# Ahsan Composite Ltd.

27 April 2014

# Observations

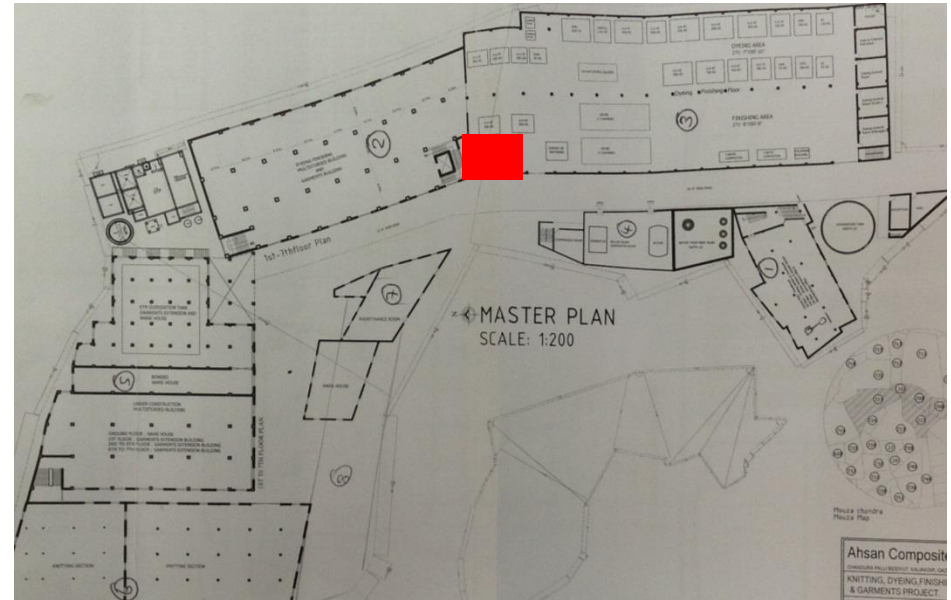
# Buildings 1 and 2 - Heavy storage loads on slabs

- Columns under ends of beams removed to accommodate ground floor plant.
- The beams are therefore now cantilevering.
- Although beams are currently not live loaded, there is a blockwork wall at the tip of the cantilever and the cantilever is sagging by about 40mm.

Column cut at mid-height and propped with bricks

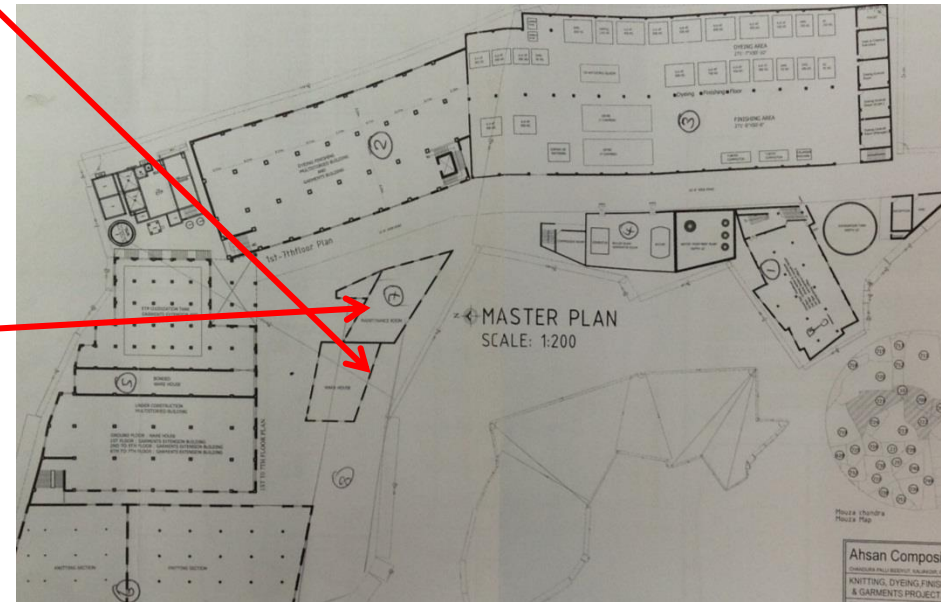
## Holes broken through walls.

- In left hand image the broken column on the right supports the roof truss; the adjacent length of brick wall is propped only by a single stack of bricks.
- Although building will shortly be demolished, in the short term it is still accessed and used for storage.

Item No.	Observation	Recommended Action Plan	Recommended Timeline
12	Building 7 - Column cut at mid-height and propped with bricks	Since building will shortly be demolished, we recommend temporarily bricking up the wall and then grouting the gaps in the columns.	<b>Immediate - Now</b>
13	Building 7 - Column cut at mid-height and propped with bricks	Works will need to be undertaken very carefully to avoid collapse during the works. Factory Engineer to be present at all times.	<b>Immediate - Now</b>
14	Building 7 - Column cut at mid-height and propped with bricks	Because this was an immediate safety issue it was raised with the factory owner at the close-out meeting, who agreed to repair the wall the next day. The photograph on the following slide was received the next day showing repairs completed.	<b>Immediate - Now</b>
15	Building 5 - Missing beams around stair and discrepancies between as-built and structural drawings	Build brick wall (A) off ground floor to support full width of half landing and (B) to support full length of edge of slab.	<b>Immediate - Now</b>

**Missing beams around stair**

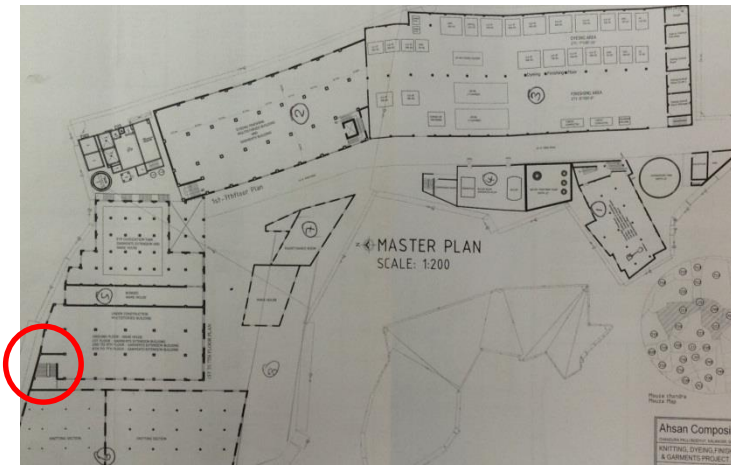
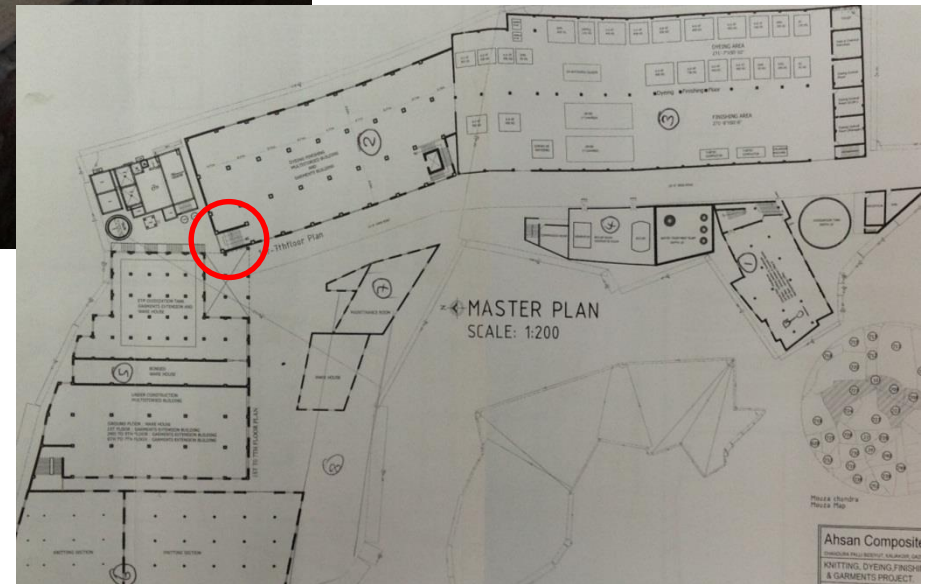
**At the level above, the stair opening is framed by beams.**

**However, at 1<sup>st</sup> floor there are no beams, meaning that the 105thk slab must span approx. 7m supporting itself, the stair which hangs from it and the wall which is built off it.**

16	Building 5 - Missing beams around stair and discrepancies between as-built and structural drawings	Because this was an immediate safety issue it was raised with the factory owner at the close out meeting, who agreed to construct wall A the next day. The photograph on the following slide was received the next day showing construction of wall A already in progress.	<b>Immediate - Now</b>
17	Building 5 - Missing beams around stair and discrepancies between as-built and structural drawings	Engineering assessment of area to be undertaken by Factory Engineer. Assessment also to include location along North side of building where stepped slab edge has been changed to a diagonal (see previously noted observations).	<b>6-weeks</b>

# Building 4 - Extension to cantilever slab

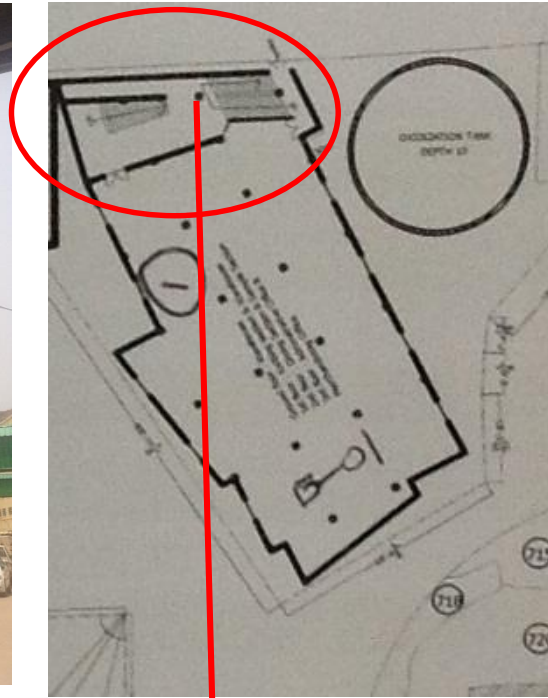
Original cantilever slabs at 1<sup>st</sup> and 2<sup>nd</sup> floors have been extended.

It is difficult to see how the new reinforcement can have been adequately anchored.

**Buildings not as drawings or permits: including additional structures, missing columns and cantilevers without backspans**

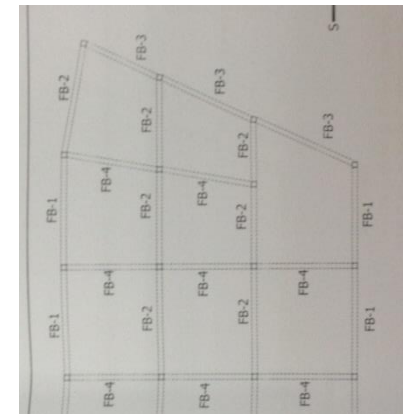
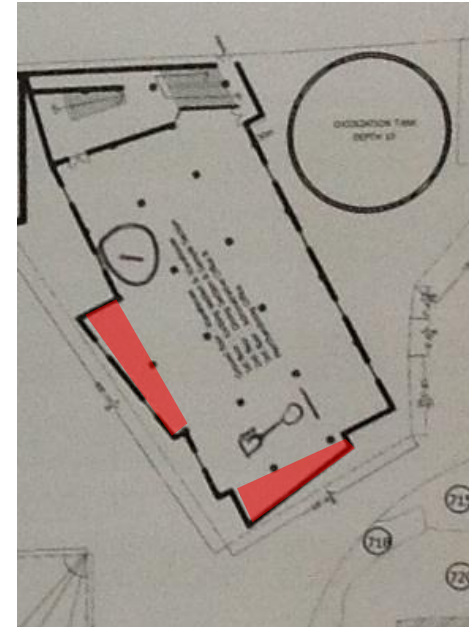
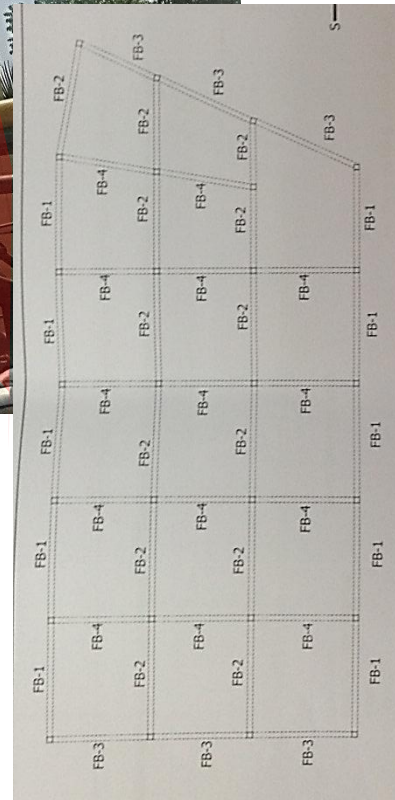
- Along the front elevation, the as-built layout and the architectural drawing (left) are different from the simple structural layout (below).
- Beams and columns have a different layout, and the edge cantilever is missing a backspan (bottom left image) due to the adjacent staircase.

The two red shaded areas on the architectural layout (below) are not reflected on the structural drawing (below left). They appear to be variously supported by RC beams and loadbearing half brick walls.

**Building 1 - Floor slabs larger than shown on structural drawing**

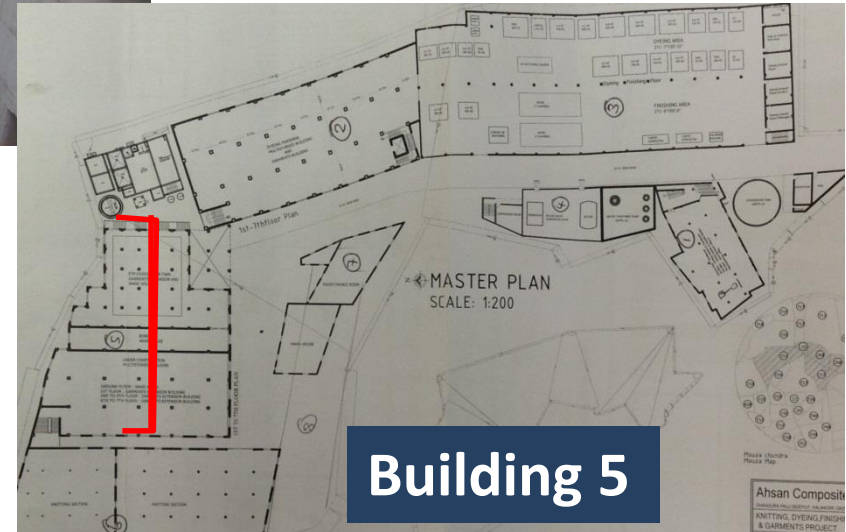
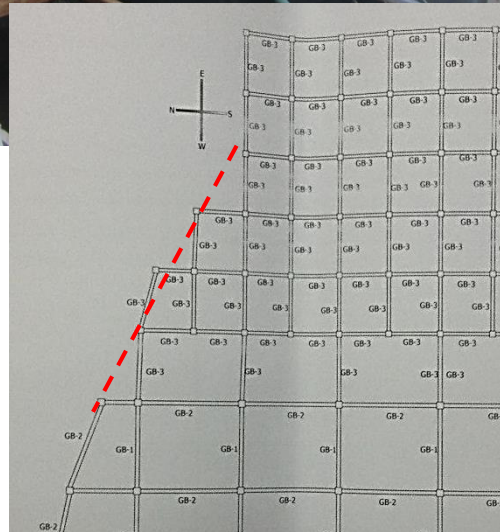
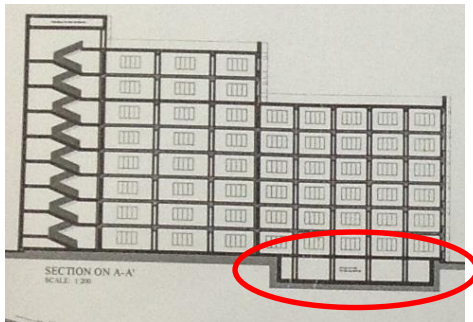
Cross-section shows a basement reservoir, but actual reservoir is at ground floor.

Also, the stepped slab edge as drawn at all floors has been changed to a diagonal (see dashed line on plan, bottom centre).

**Building 3 - No structural drawings  
for 2-storey RC structure**

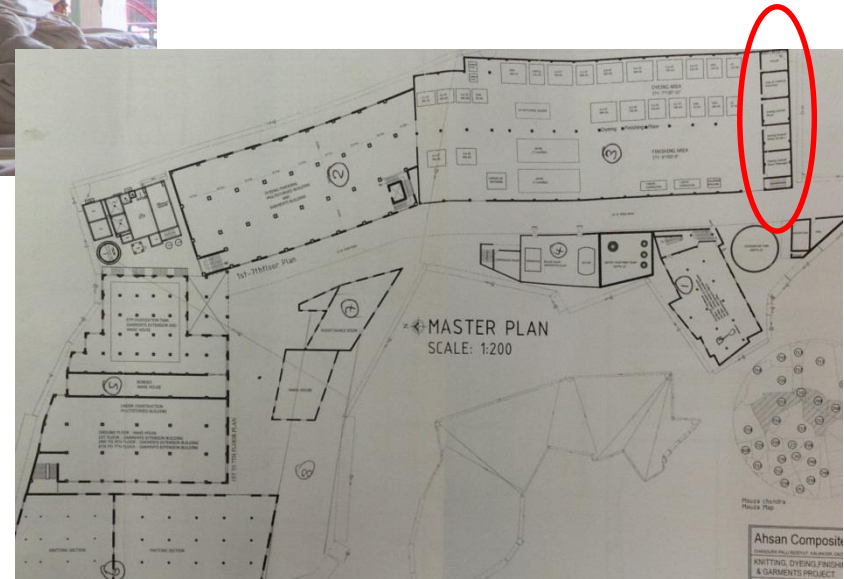
No structural drawings  
for 2 storey RC structure

**Building 5 - Columns at risk of vehicle impact**

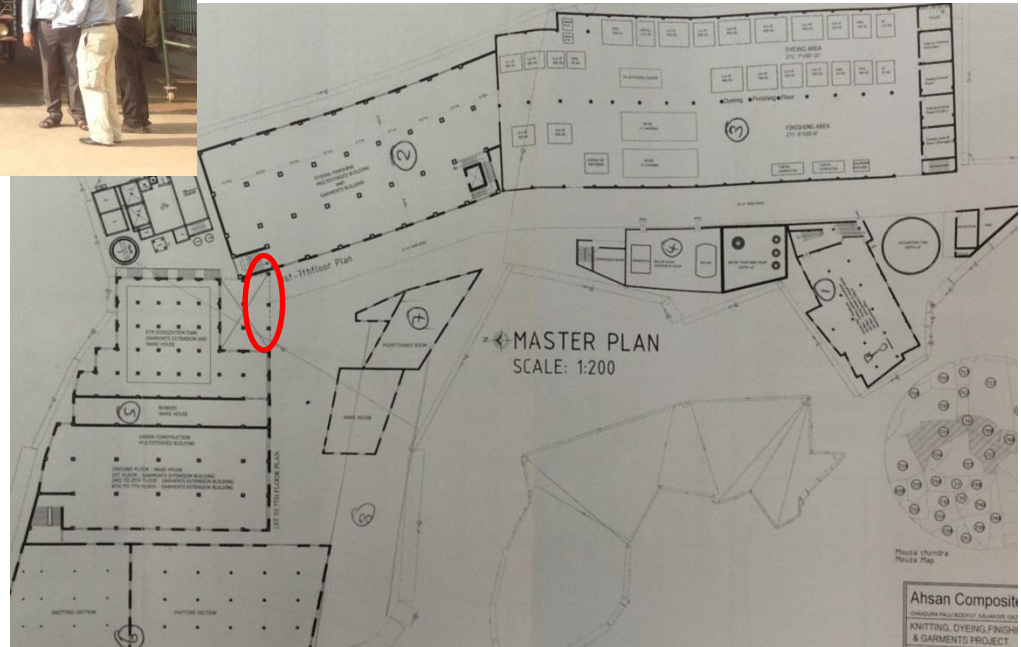
Tall loading bay columns (which carry the building above) have no protection against vehicle impact.

25	Building 5 - Columns at risk of vehicle impact	Install bollards, spaced away from the columns, to protect the columns from impact.	<b>6-weeks</b>

## Building 3 - Columns pinned at mid-height

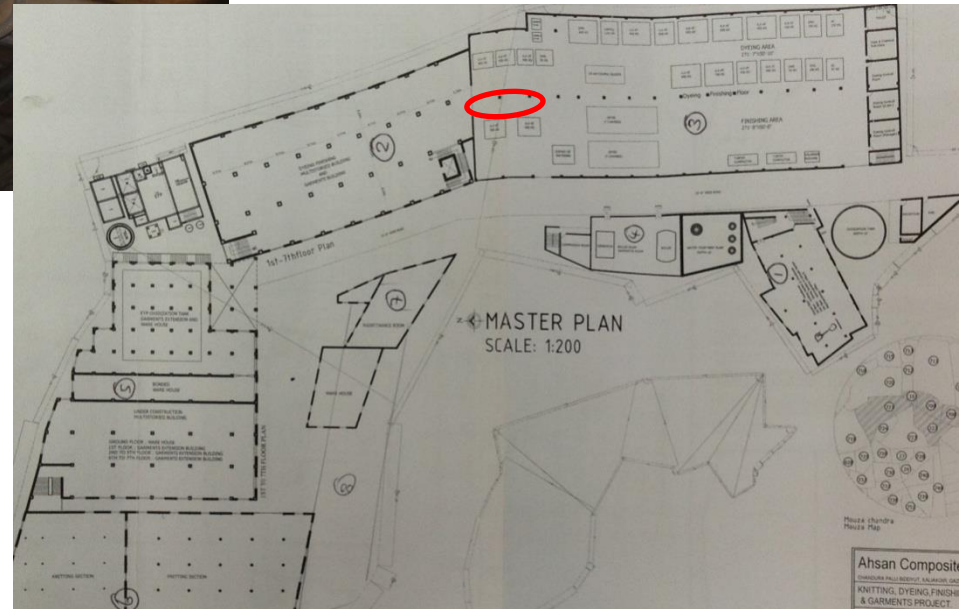
- Two steel columns supporting roof are built off 2.5m high RC columns.
- Steel baseplate has inadequate fixing into the RC column.
- It is also unlikely that the RC column was designed as a cantilever, in which case the column is effectively pinned at mid-height.

Item No.	Observation	Recommended Action Plan	Recommended Timeline
26	Building 3 - Columns pinned at mid-height	Engineering assessment of columns to be undertaken by Factory Engineer.	6-weeks
27	Building 3 - Columns pinned at mid-height	Implement actions arising from assessment, including strengthening if required.	6-months
28	Building 5 - Poorly compacted beam	Provide structural repair under supervision of Factory Engineer.	6-weeks
29	Buildings 1 & 2 - Rubble and bricks on roofs	Bricks and rubble to be removed.	6-weeks
30	Building 2 - Structurally unsafe access ramp	Replace with new ramp, to be designed by Factory Engineer.	6-weeks
31	Buildings 3 & 6 - Non-engineered steel sheds including weak roof connections, no roof bracing and potentially missing lintels and unrestrained brick facades	Engineering assessment of steel sheds to be undertaken by Factory Engineer.	6-weeks
32	Buildings 3 & 6 - Non-engineered steel sheds including weak roof connections, no roof bracing and potentially missing lintels and unrestrained brick facades	Implement actions arising from assessment, including strengthening if required.	6-months

**Building 5 –  
Very poorly compacted beam**

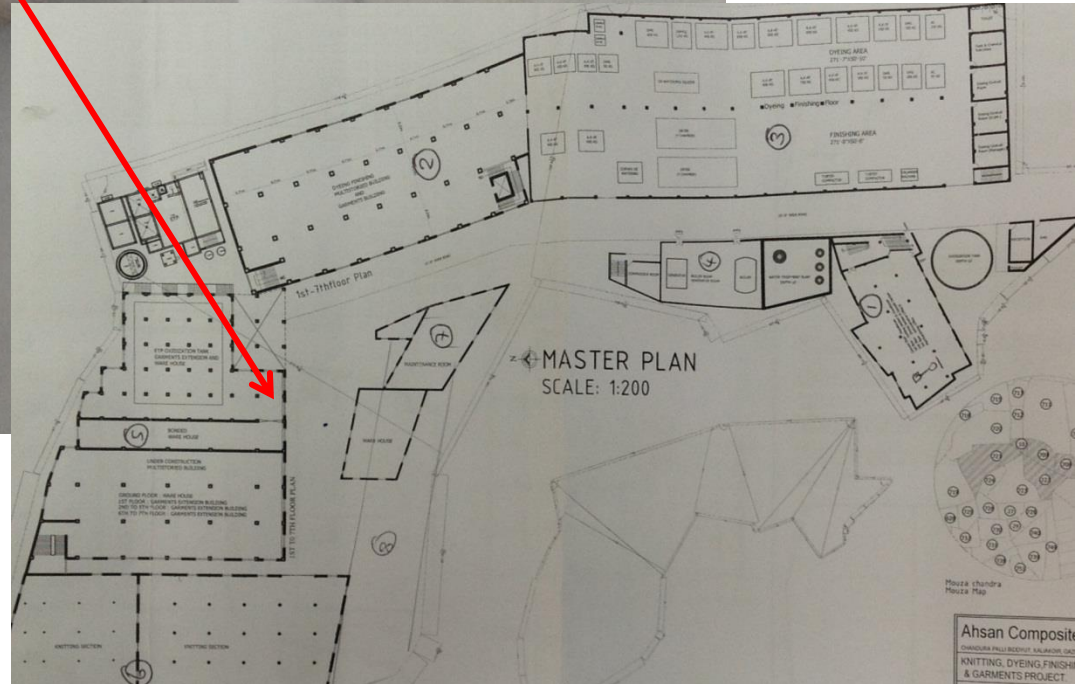
**Coarse aggregate is exposed along full length of the beam, suggesting lack of vibration.**

## Building 1 – RC column damaged by fixings

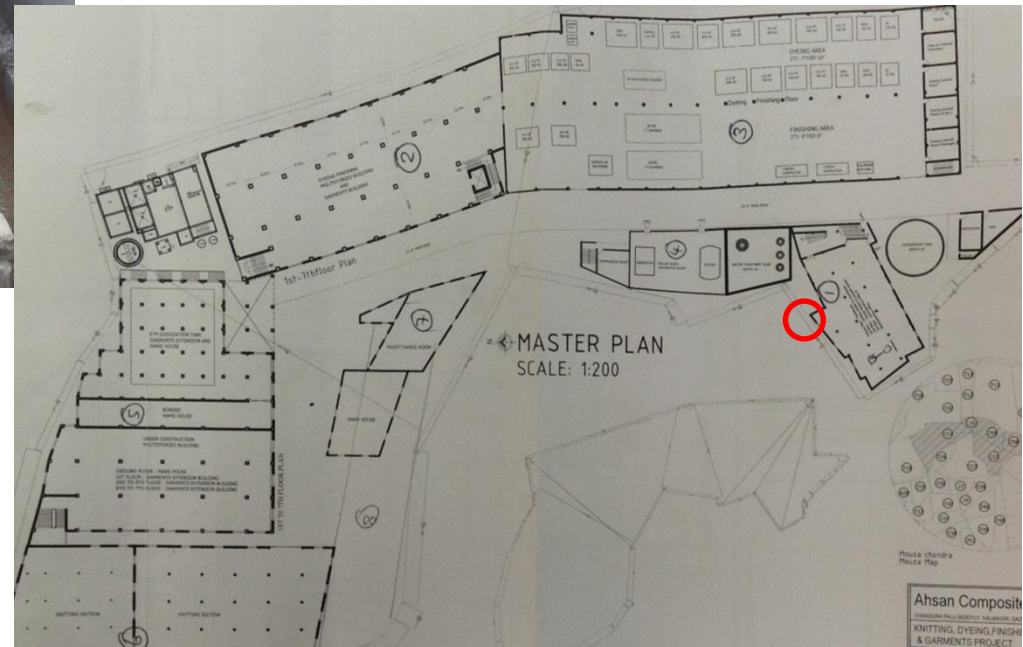
Gate hinges had been fixed to small RC column supporting corner of building. Concrete has been poorly made good at hinge locations and is spalling, suggesting corrosion of the reinforcement.

Item No.	Observation	Recommended Action Plan	Recommended Timeline
33	Building 1 - RC column damaged by fixings	Factory Engineer to inspect damage to columns.	6-weeks
34	Building 1 - RC column damaged by fixings	Repairs to column to be made under direction of Factory Engineer.	6-months
35	Building 3 - Office building framing not consistent with drawings; adjacent leaning partition	Engineering assessment to be undertaken by Factory Engineer.	6-months
36	Building 3 - Office building framing not consistent with drawings; adjacent leaning partition	Carry out actions arising from assessment.	6-months
37	Building 3 - Office building framing not consistent with drawings; adjacent leaning partition	Drawings to be amended to show as-built condition (after any remedial works).	6-months
38	ETP - Very large and heavily loaded RC water tanks	Engineering assessment of water tanks to be made by Factory Engineer.	6-months

**Buildings 3 and 6 –  
Non-engineered steel sheds including weak roof  
connections, no roof bracing, potentially missing  
lintels and unrestrained brick facades**

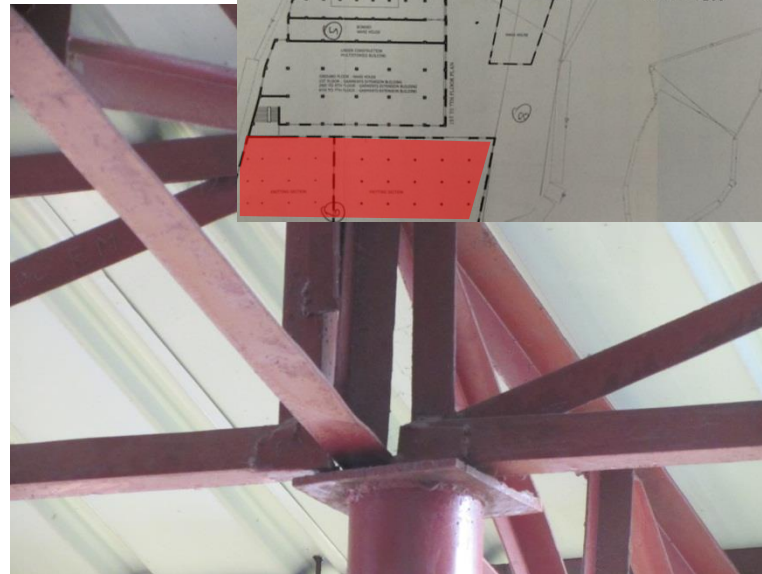
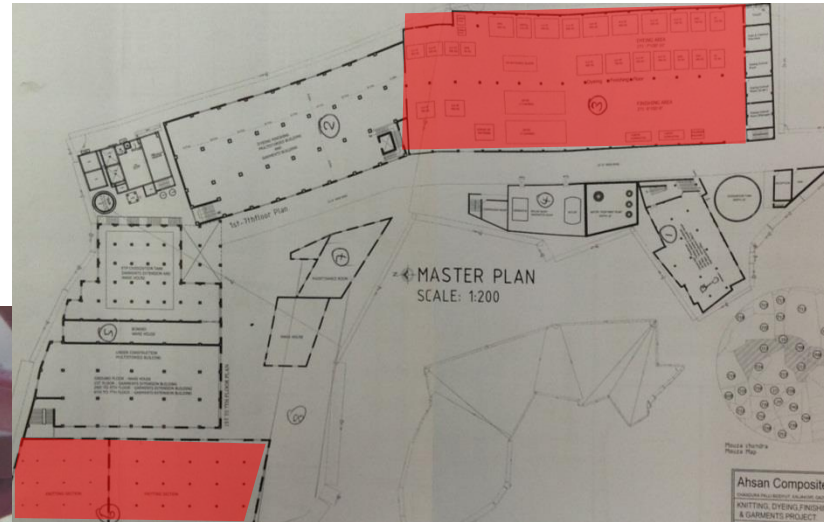
Non-engineered steel sheds including weak roof connections, no roof bracing, potentially missing lintels and unrestrained brick facades.

# Building 3 - Leaning partition

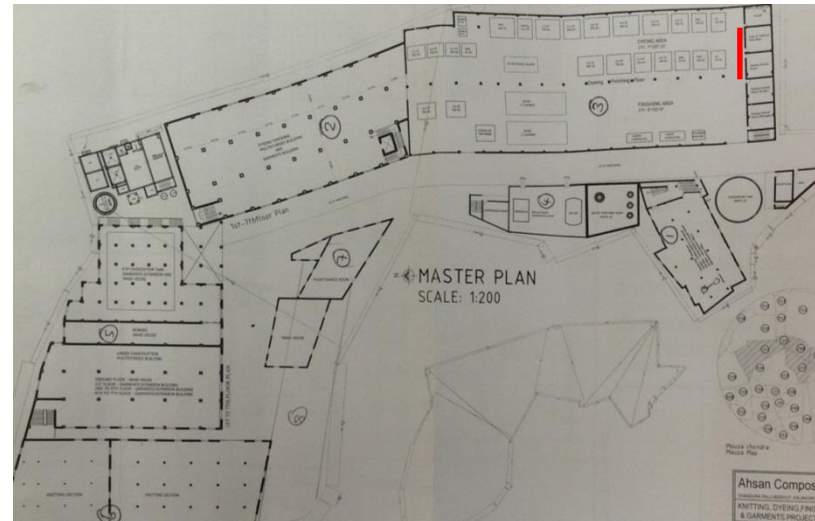
Partition (bottom left) is visibly leaning outwards. Stability will depend on degree of bonding to the buttresses built against the rear face.

# Buildings 1 and 2 - Rubble and bricks on roof

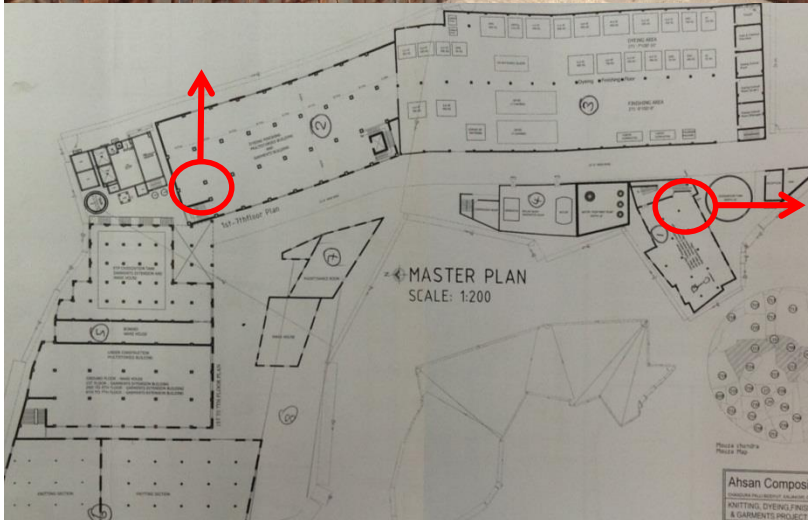
Heavy brick loading on roofs (left, where brick structure has been demolished, and right, where bricks are being stored during construction of roof parapets).

Large RC water tanks

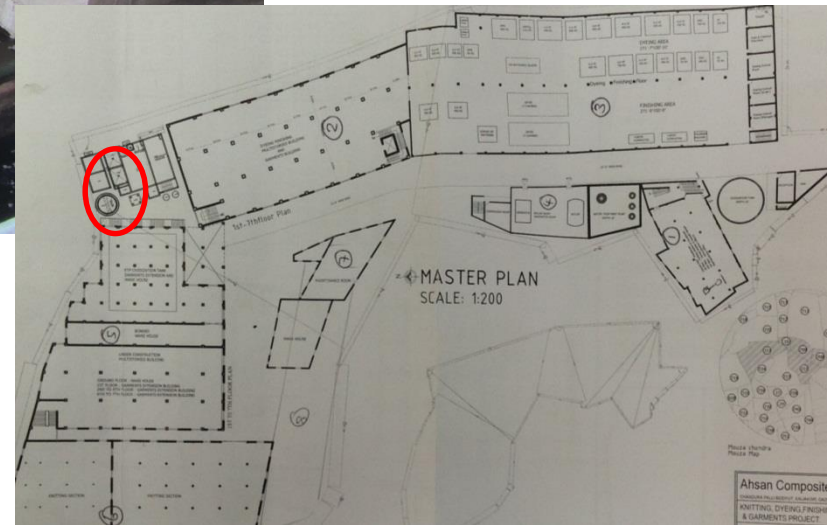
Vertical and lateral loads on RC tanks will be significant.

39	ETP - Very large and heavily loaded RC water tanks	Implement actions arising.	6-months
